ADDENDUM #7

Date: October 21, 2026

Project: New Locker Room Facility and Renovations to the
Existing Concession and Tennis Facilities Project at the
Merrillville High School
276 E 68th Place
Merrillville, Indiana 46410

Architect's Project #26027

SHEET
C 1.0.0
-A,B,C,D

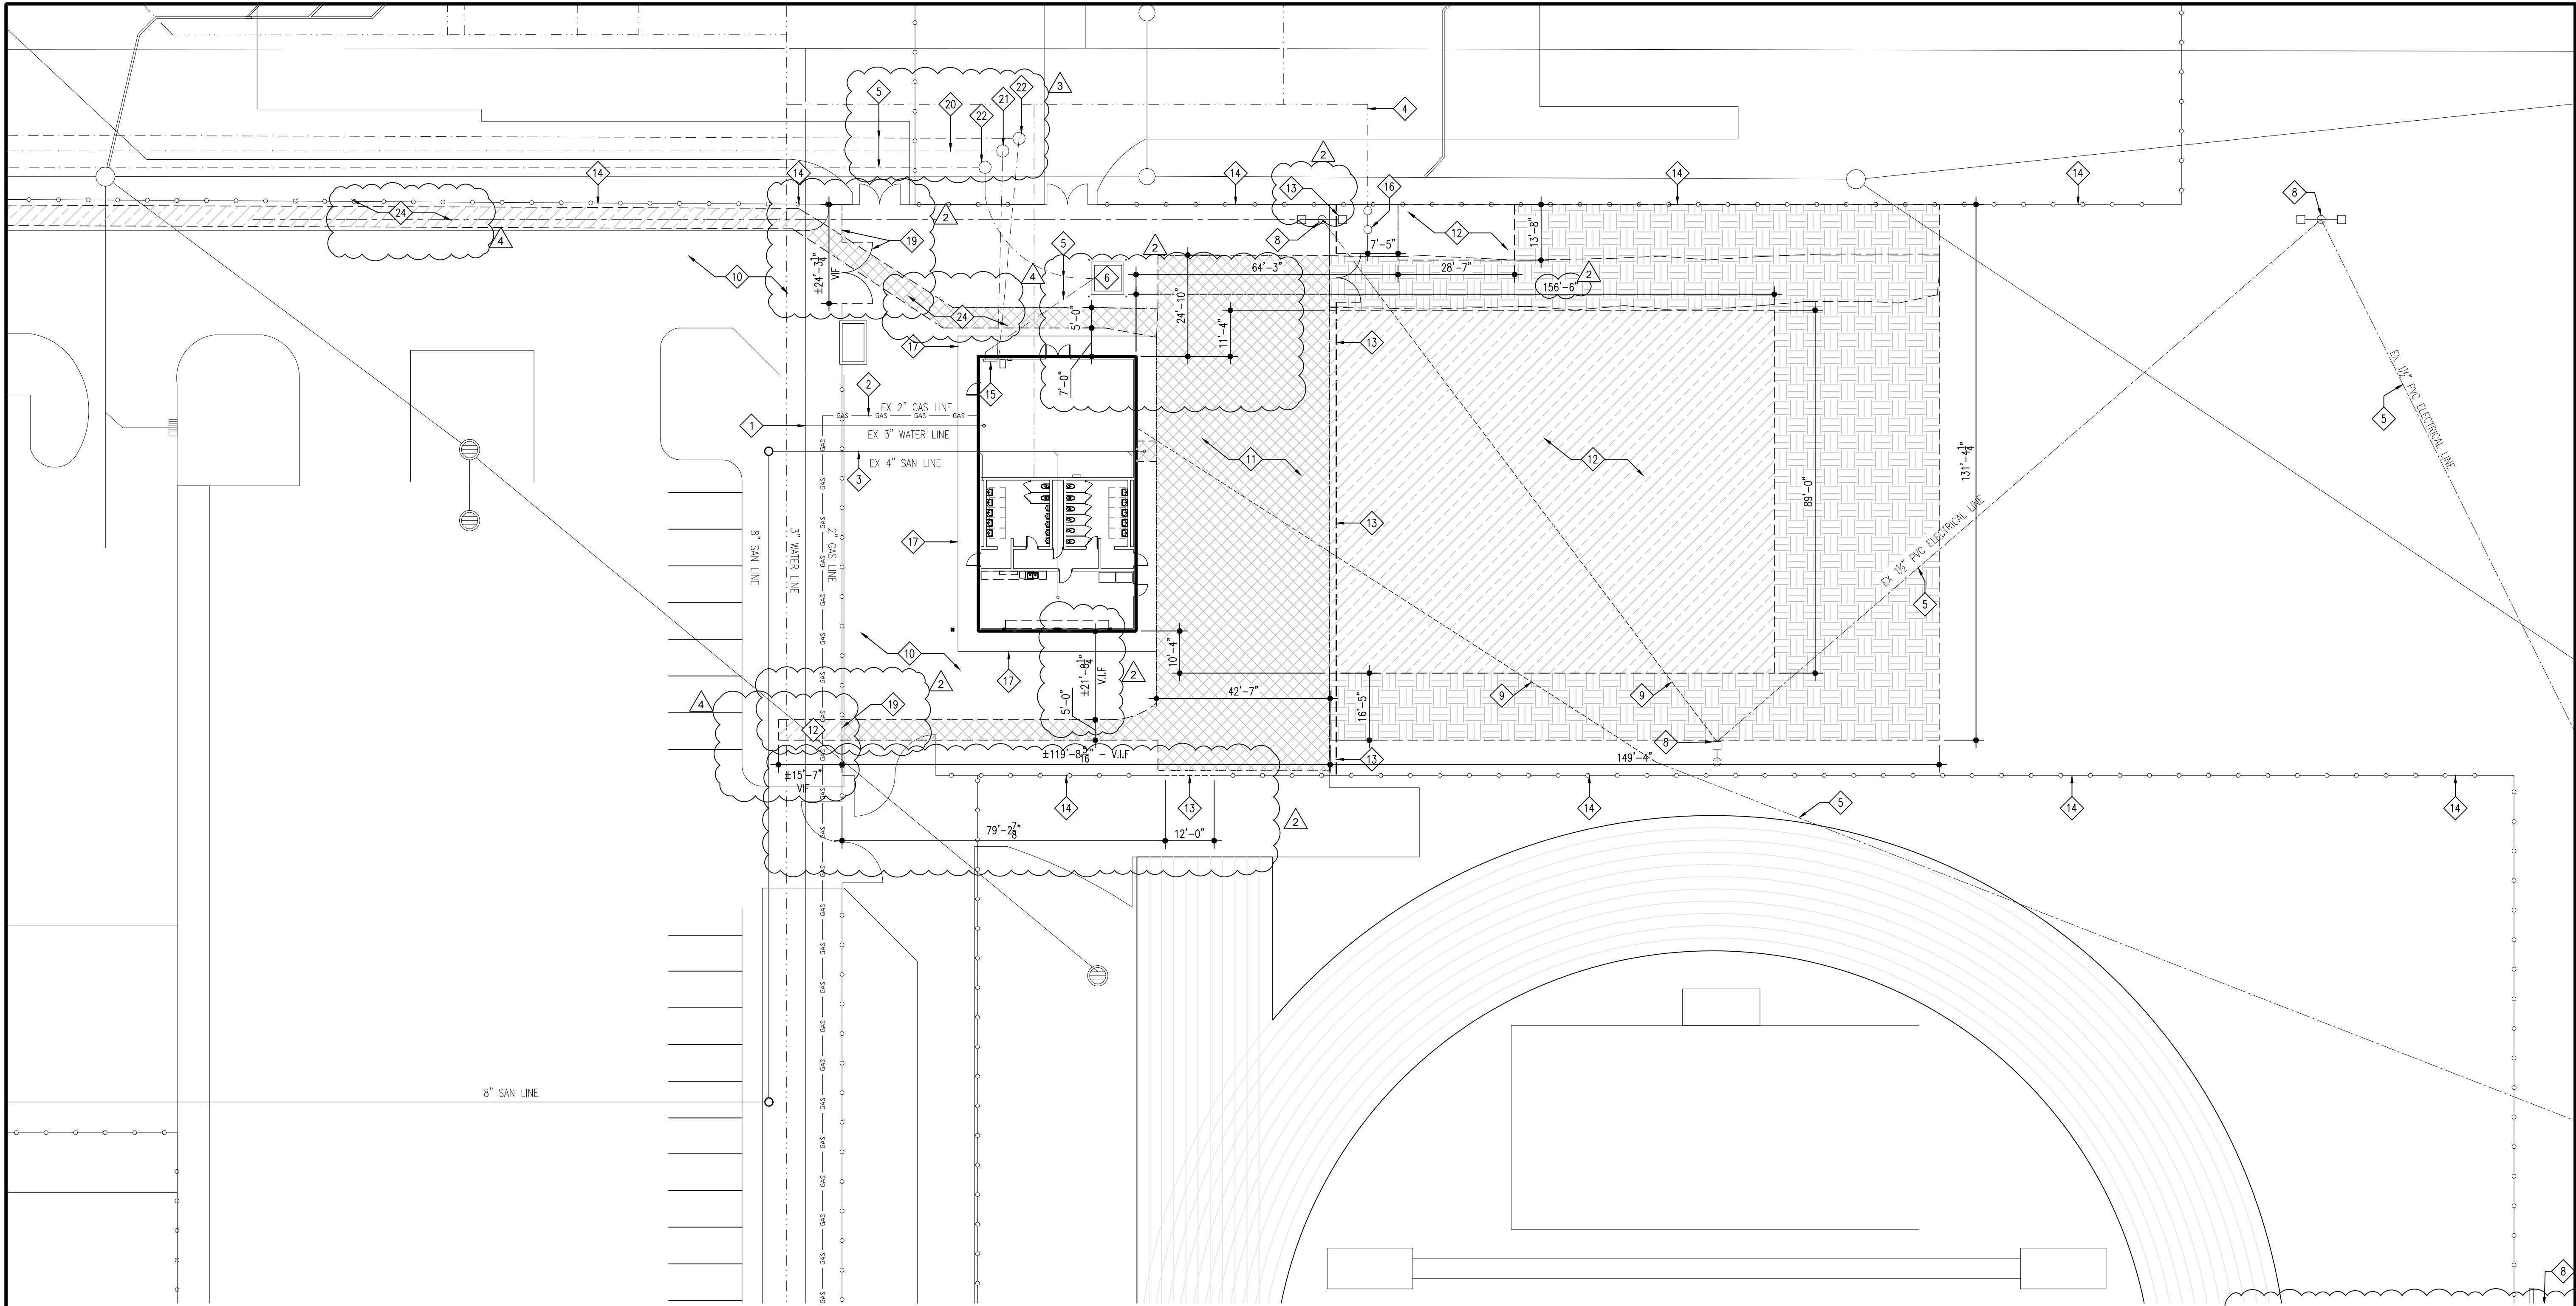
5. See attached Revised Drawing Sheet C1.0.0-ABCD – Master Site Plan – Merrillville High School Campus - This plan shows clouded and tagged revisions dated 10/21/2026.
6. See attached Revised Drawing Sheet C1.0.2-AC – Partial Site Plan – Demolition – Existing Concession & new Locker Room Facility - This plan shows clouded and tagged revisions dated 10/21/2026.
7. See attached Revised Drawing Sheet C1.0.3-B – Partial Site Plan – Demolition – Tennis Building - This plan shows clouded and tagged revisions dated 10/21/2026.
8. See attached Revised Drawing Sheet C1.0.4-D – Partial Site Plan – Demolition – High School Substation #2 - This plan shows clouded and tagged revisions dated 10/21/2026.

SHEET
C 1.1.2
- A,C

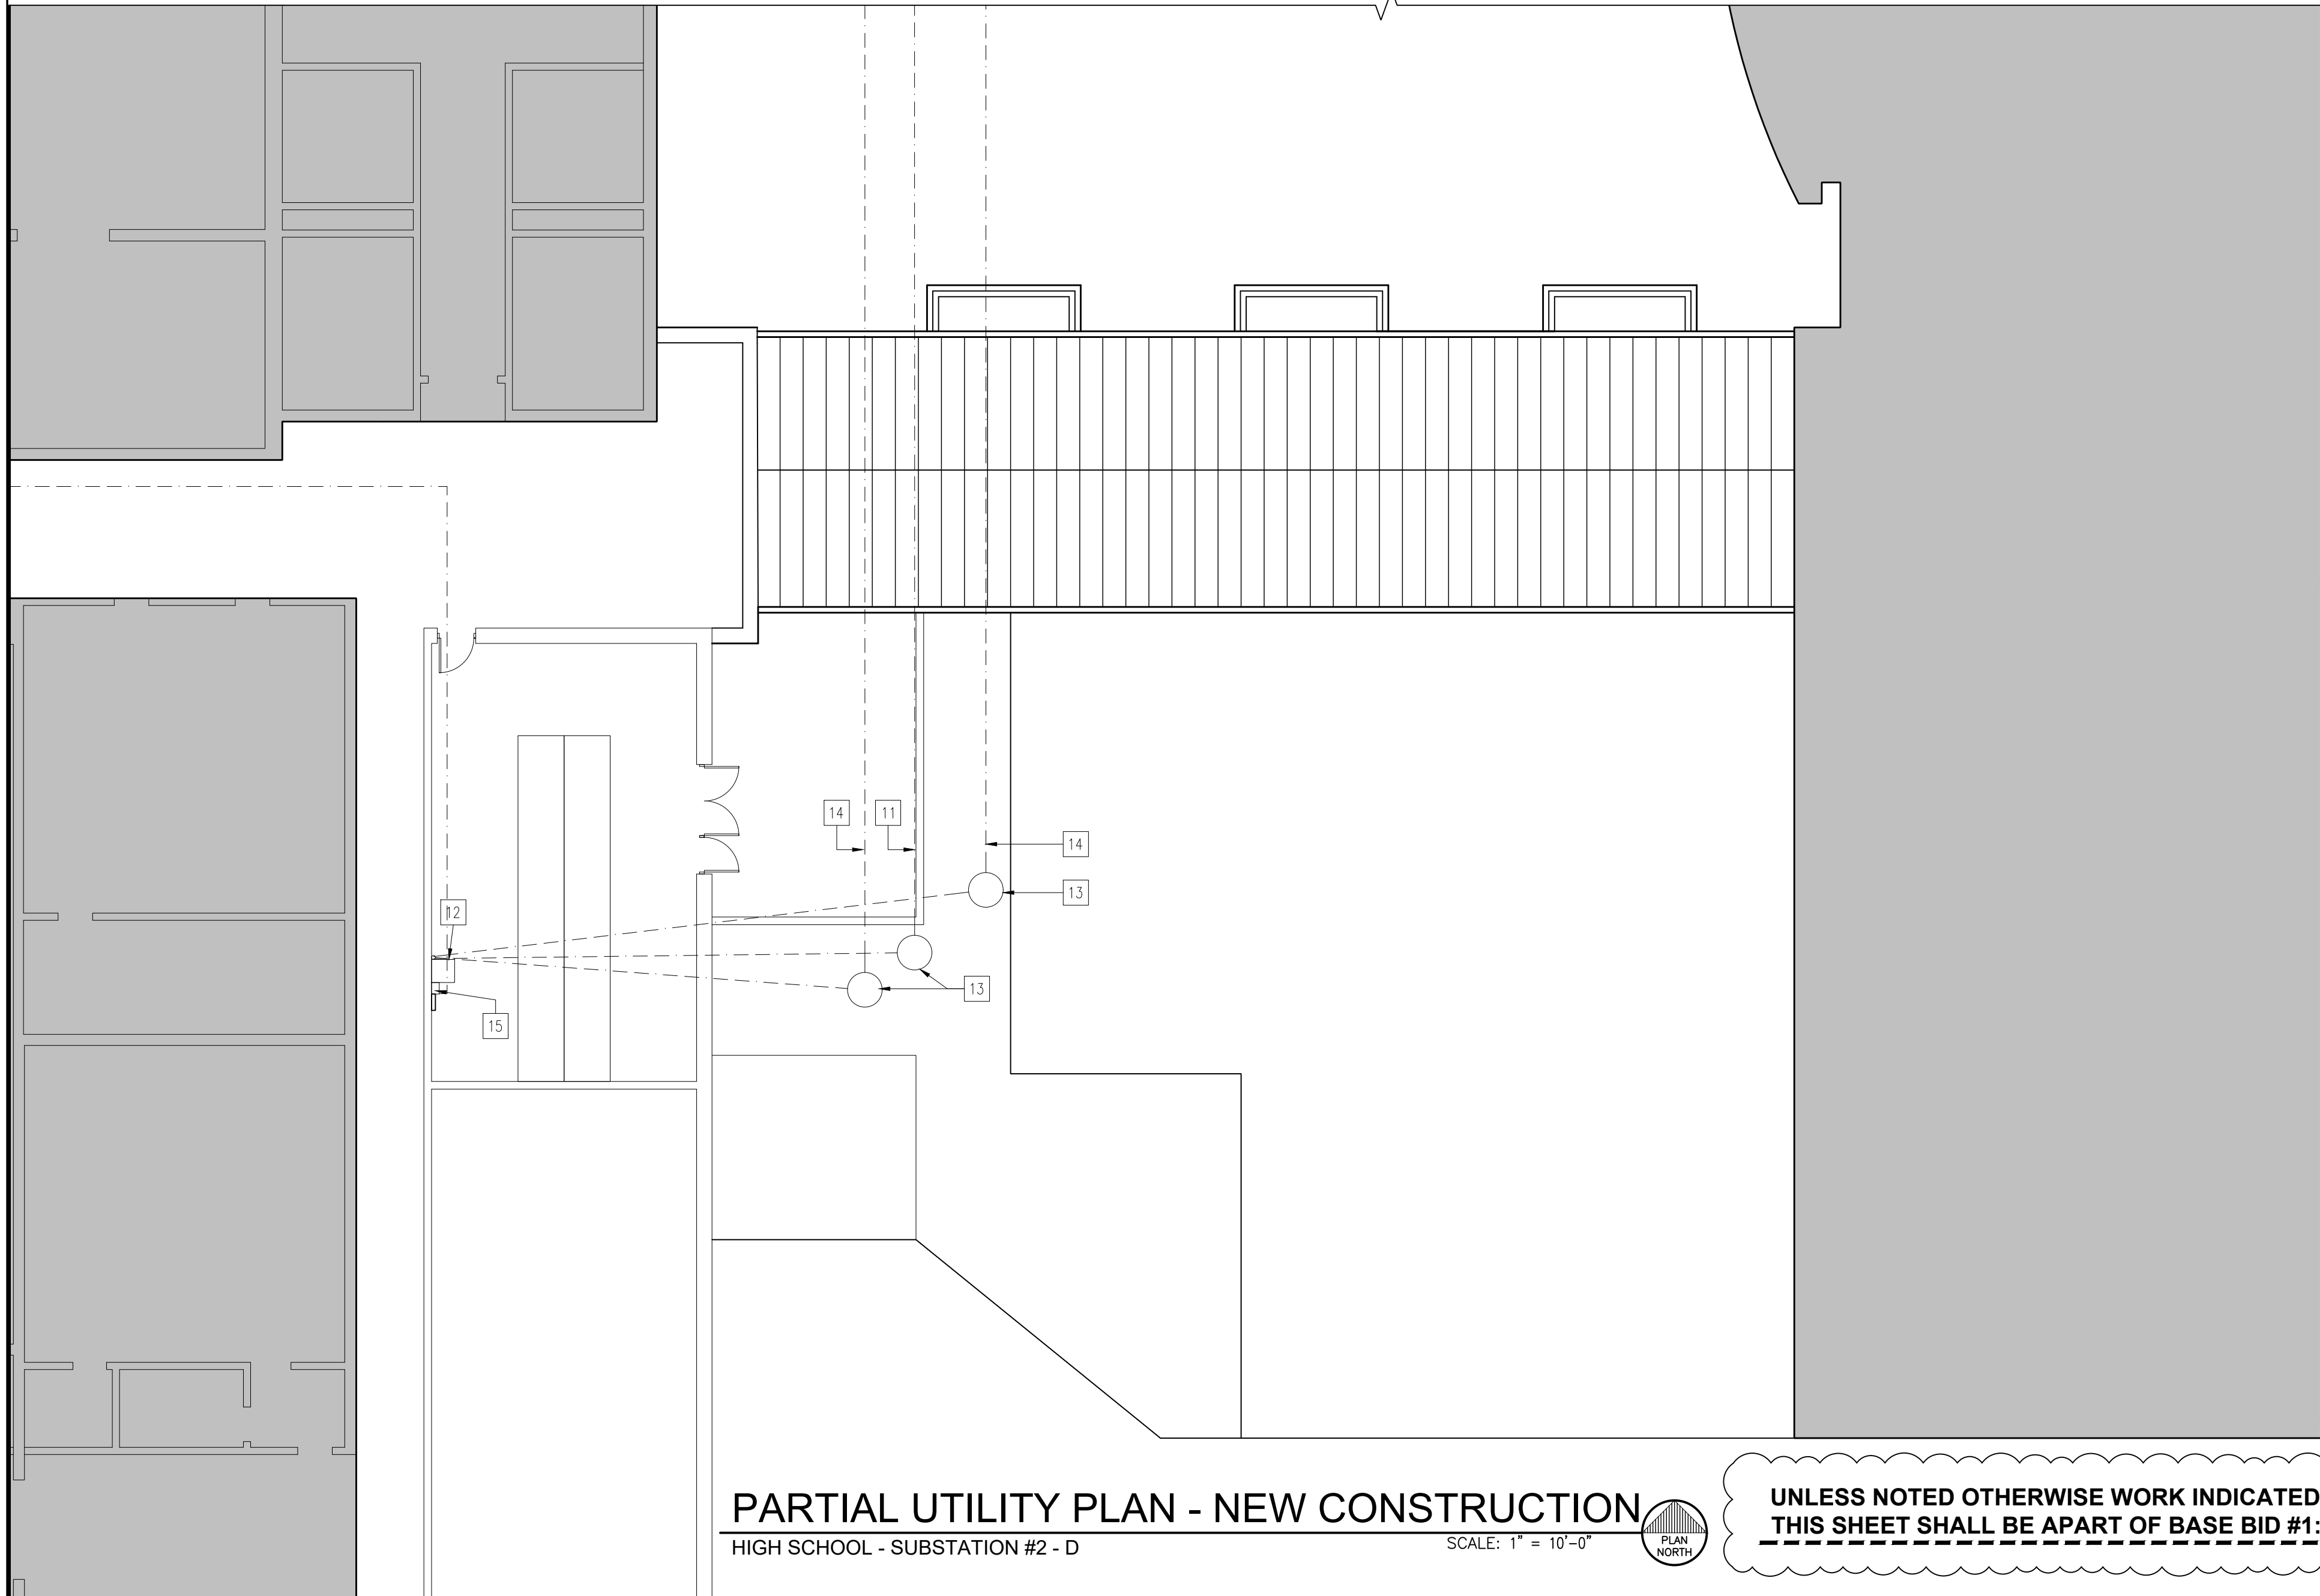
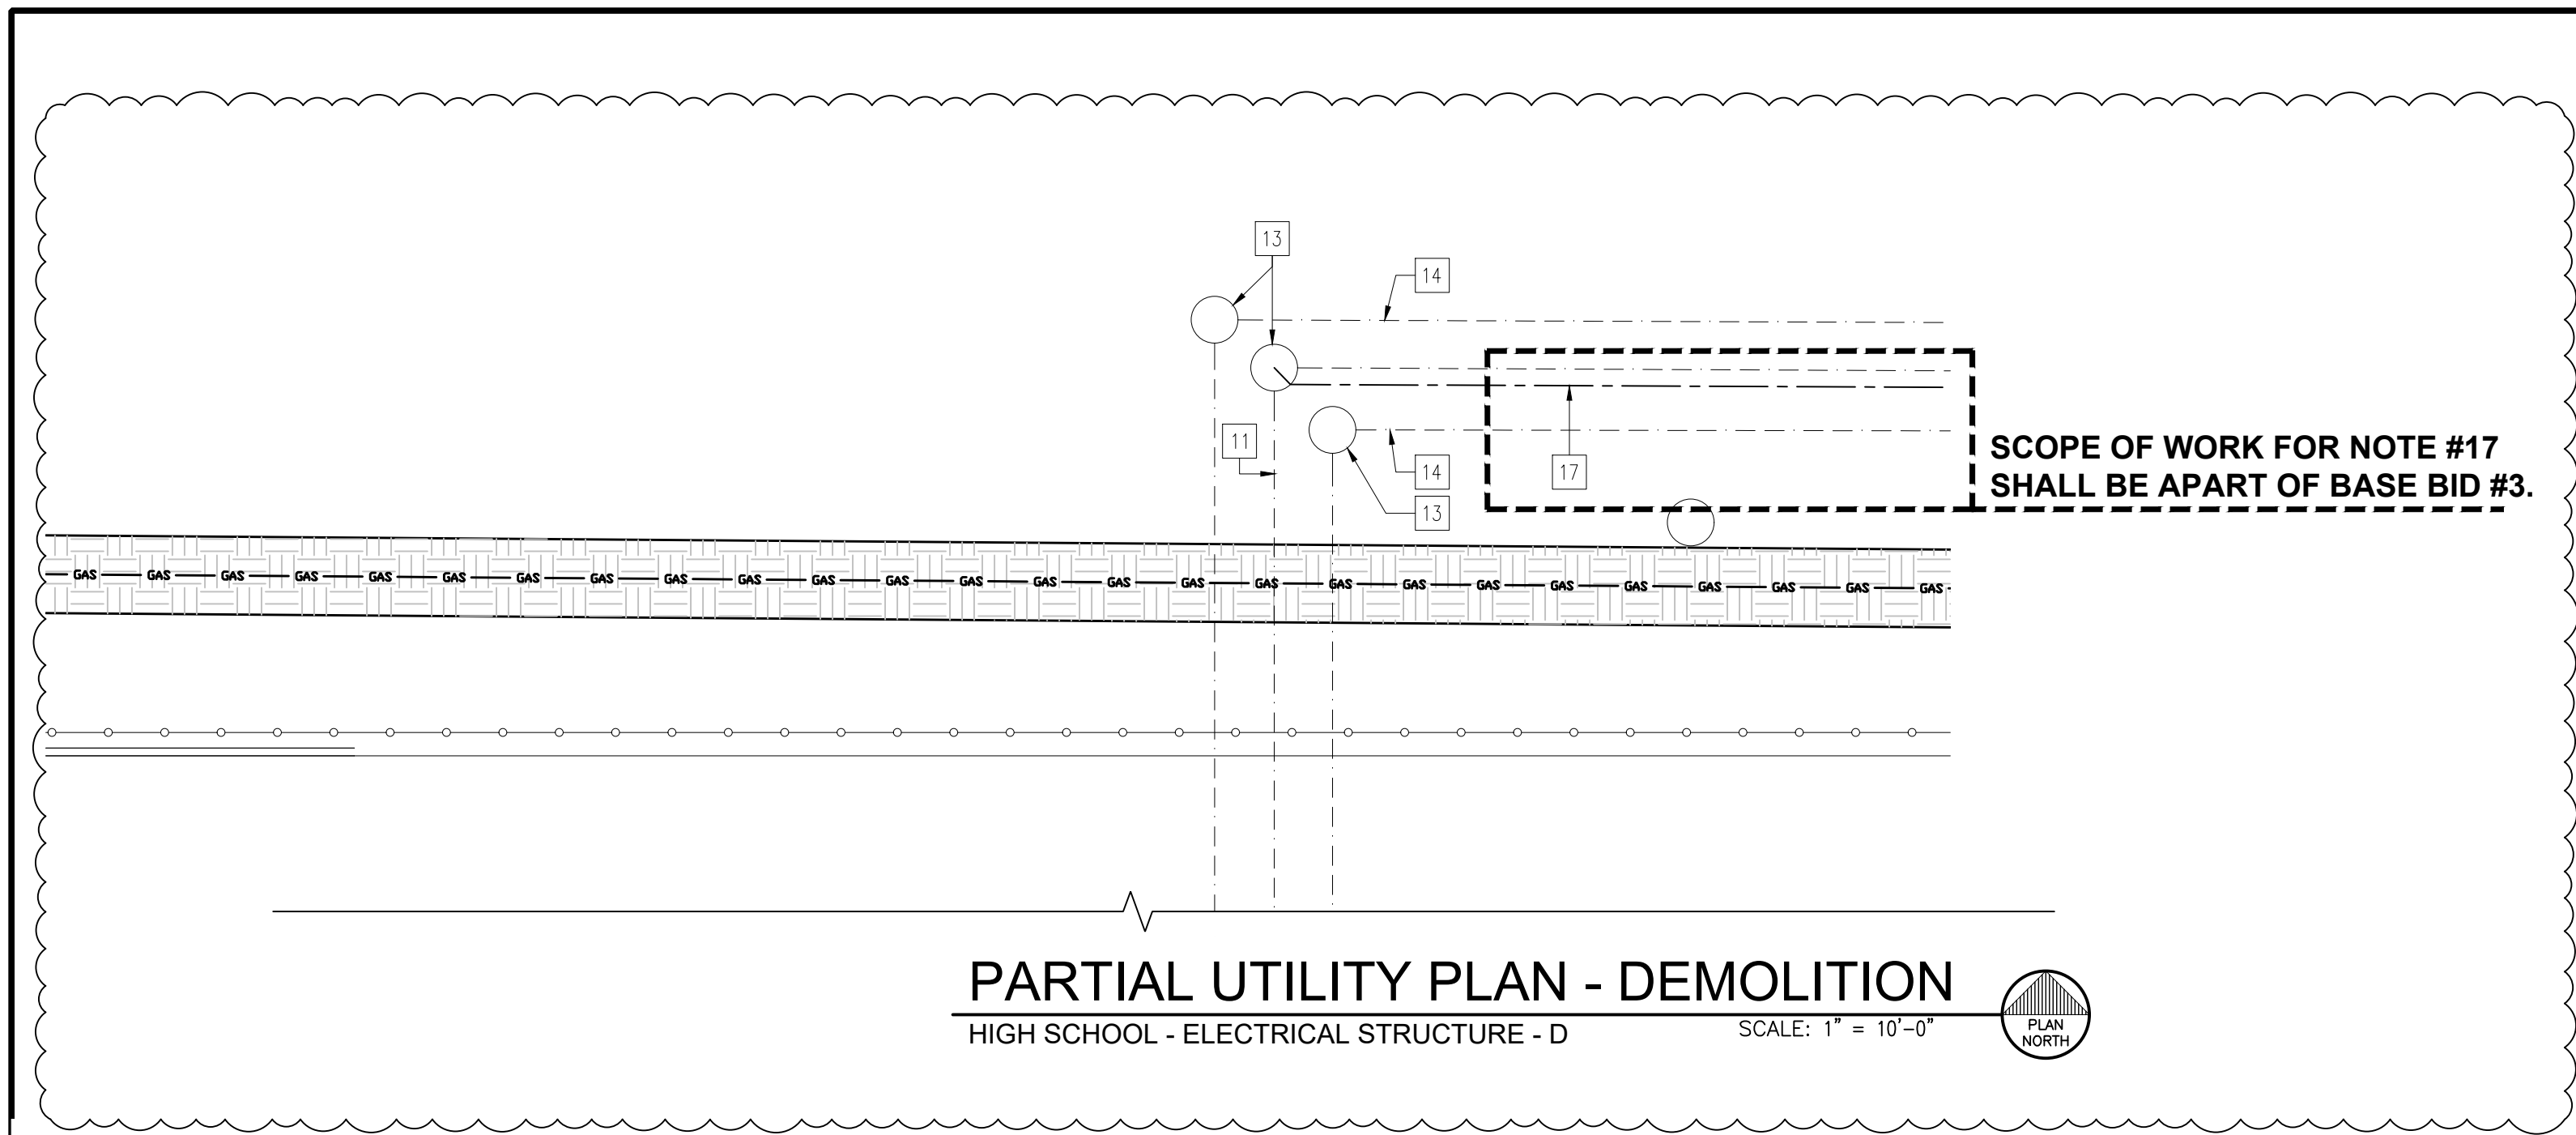
10. See attached Revised Drawing Sheet C1.1.2-AC – Partial Site Plan – New Construction – Existing Concession & New Locker Room Facility - This plan shows clouded and tagged revisions dated 10/21/2026.
